Errata to **MCF5206e ColdFire Microprocessor** **User's Manual, rev. 3.0**

This errata describes corrections to the *MCF5206e User's Manual*. For convenience, the section number and page number of the errata item in the user's manual are provided.

Figure 1. Longword Write Transfer from a 32-Bit Port (Address Setup, No Wait State, No Address Hold)

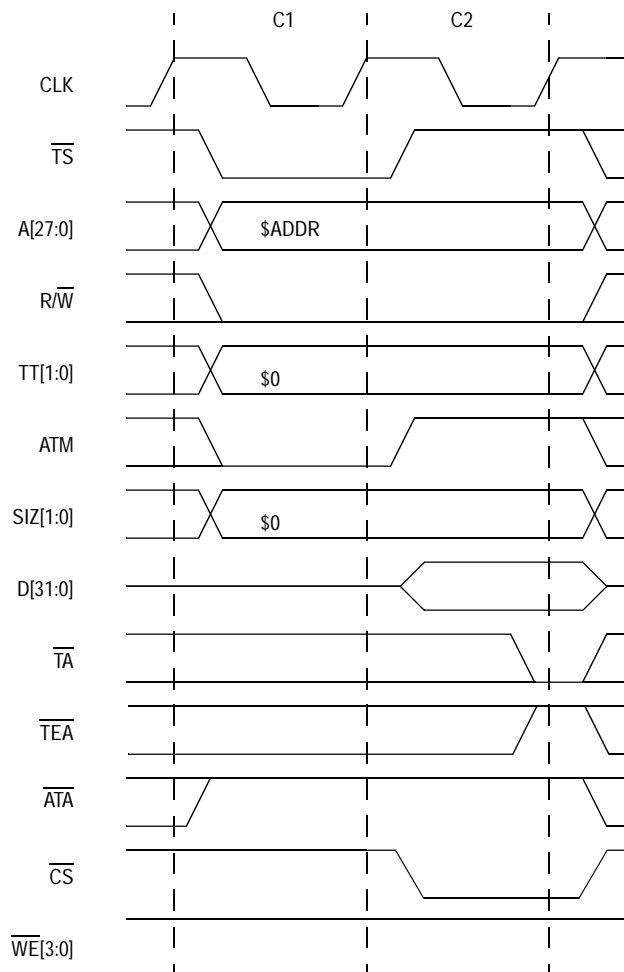
9.3.3.1, 9-9 Add the following paragraphs.

9.3.3.1a Nonburst Transfer with Address Setup, No Address Hold, No Wait State.

The write cycle starts in C1. During C1, the MCF5206e places valid values on the address bus (A[27:0]) and transfer control signals. The transfer type (TT[1:0]) signals identify the specific access type and access type and mode (ATM) is driven low to identify the transfer as data. The read/write (R/W) signal is driven low for a write cycle, and the size signals (SIZ[1:0]) are driven low to indicate a longword transfer. The MCF5206e asserts transfer start (TS) to indicate the beginning of a bus cycle. Note $\overline{\text{WE}}[3:0]$ are never asserted.

During C2, the MCF5206e asserts the appropriate chip select ($\overline{\text{CS}}$) for the address being accessed, negates transfer start ($\overline{\text{TS}}$), drives access type and mode (ATM) high to identify the transfer as supervisor, and drives data onto D[31:0]. If the selected device(s) is ready to latch the data, it latches D[31:0] and asserts the transfer acknowledge ($\overline{\text{TA}}$). At the end of C2, the MCF5206e samples the level of $\overline{\text{TA}}$. If $\overline{\text{TA}}$ is asserted, the transfer of the longword is complete, and the MCF5206e negates $\overline{\text{CS}}$ after the next rising edge of CLK. If $\overline{\text{TA}}$ is negated, the MCF5206e continues to sample $\overline{\text{TA}}$ and inserts wait states instead of terminating the transfer. The MCF5206e continues to sample $\overline{\text{TA}}$ on successive rising edge of CLK until it is asserted. If the bus monitor timer is enabled and $\overline{\text{TA}}$ is not asserted before the programmed bus monitor time is reached, the cycle is terminated with an internal bus error.

Figure 16-3 shows pin values recommended for disabling JTAG with the MCF5206e in JTAG mode (MTMOD=0).

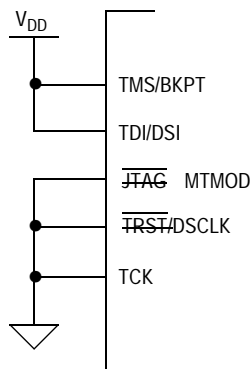
Modify the last sentence of the second paragraph and Figure 16-3 so they appear as follows:

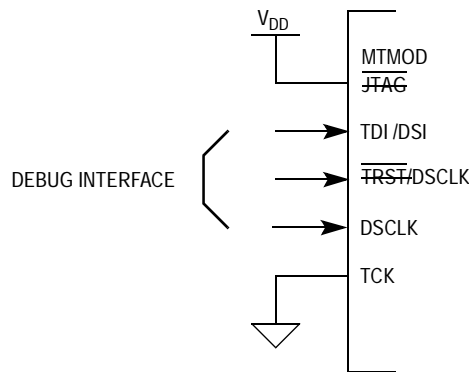
Strike out the references to $\overline{\text{TRST}}$ in the excerpt from the second paragraph shown below so that it reads as follows:

... This requires the minimum of ~~either connecting the $\overline{\text{TRST}}$ pin to logic 0, or connecting the TCK clock pin to a clock source that will supply five rising edges and the falling edge after the fifth rising edge, to ensure that the part enters the test-logic-reset state. The recommended solution is to connect $\overline{\text{TRST}}$ to logic 0.~~ Another consideration is that the TCK pin does not have an internal pull-up as is required on the TMS, TDI, and $\overline{\text{TRST}}$ pins; therefore, it should not be left unterminated to preclude mid-level input values.

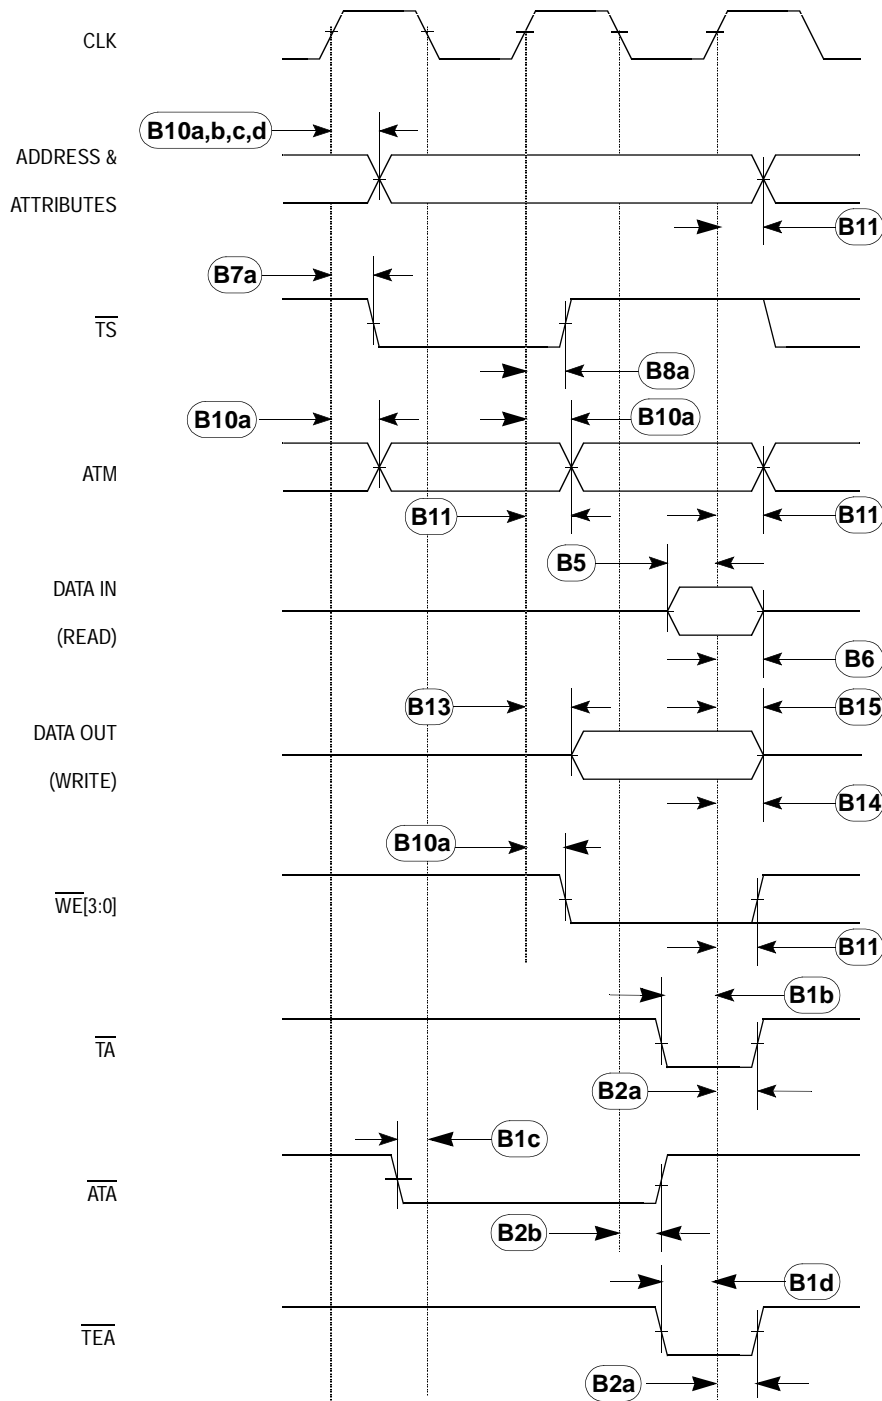
Add the following paragraph:

Although output signals that share a specification number have approximately the same timing, due to loading differences they do not necessarily change at the same time. However, they have similar timings; that is, minimum and maximum times are not mixed.
